FAQ Number 07-0038 Revision 2

FAQ Title Lessons learned on Multiple Spurious Operations

Plant: Turkey Point

Add the following section to Appendix B of NEI 04-02 Revision 2

Figure XX – Multiple Spurious Operations – Transition Resolution Process

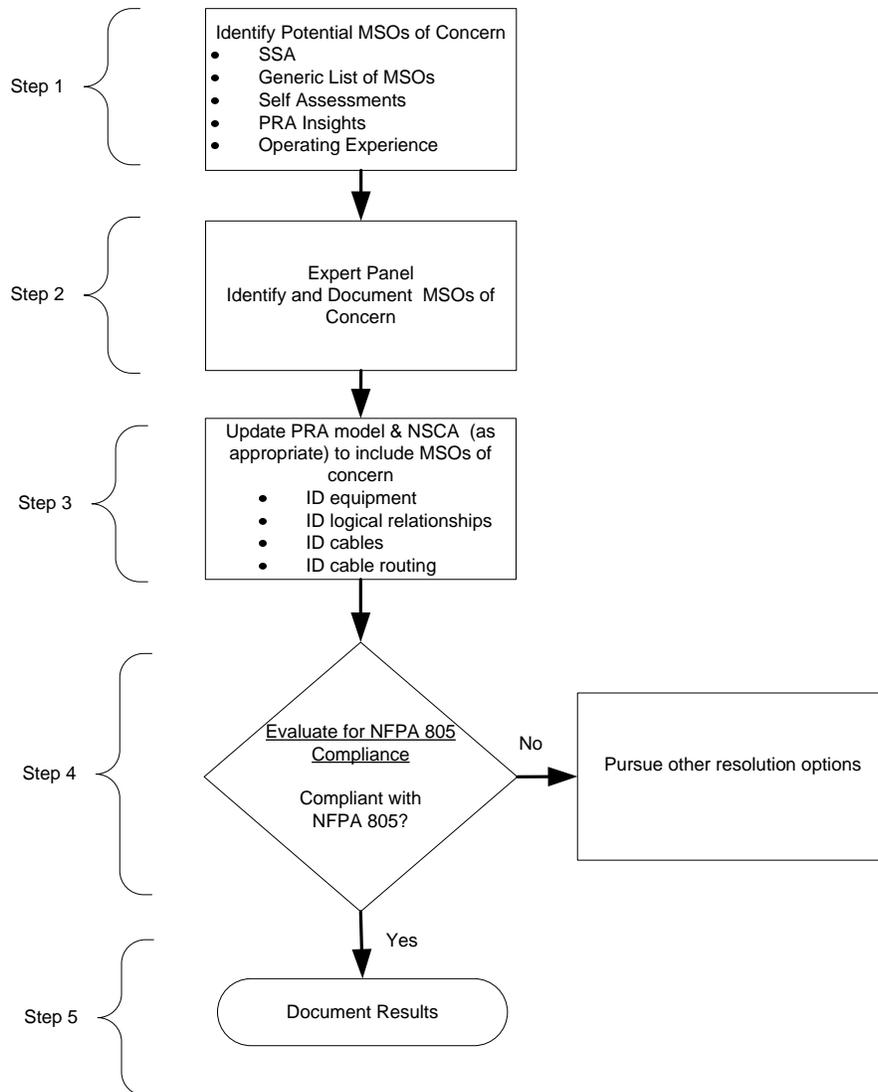
The approach outlined in Figure XX below is one acceptable method to address fire-induced MSOs. This method uses insights from a Fire PRA that meets the requirements of Regulatory Guide 1.205, Revision 1.

Step 1 - Identify potential MSOs of concern.

Step 2 - Conduct an expert panel to assess plant specific vulnerabilities (e.g., per NEI 00-01, Rev. 1 Section F.4.2).

Step 3 – Update the Fire PRA model and NSCA to include the MSOs of concern.

Step 4 – Evaluate for NFPA 805 Compliance

Step 5 - Document Results
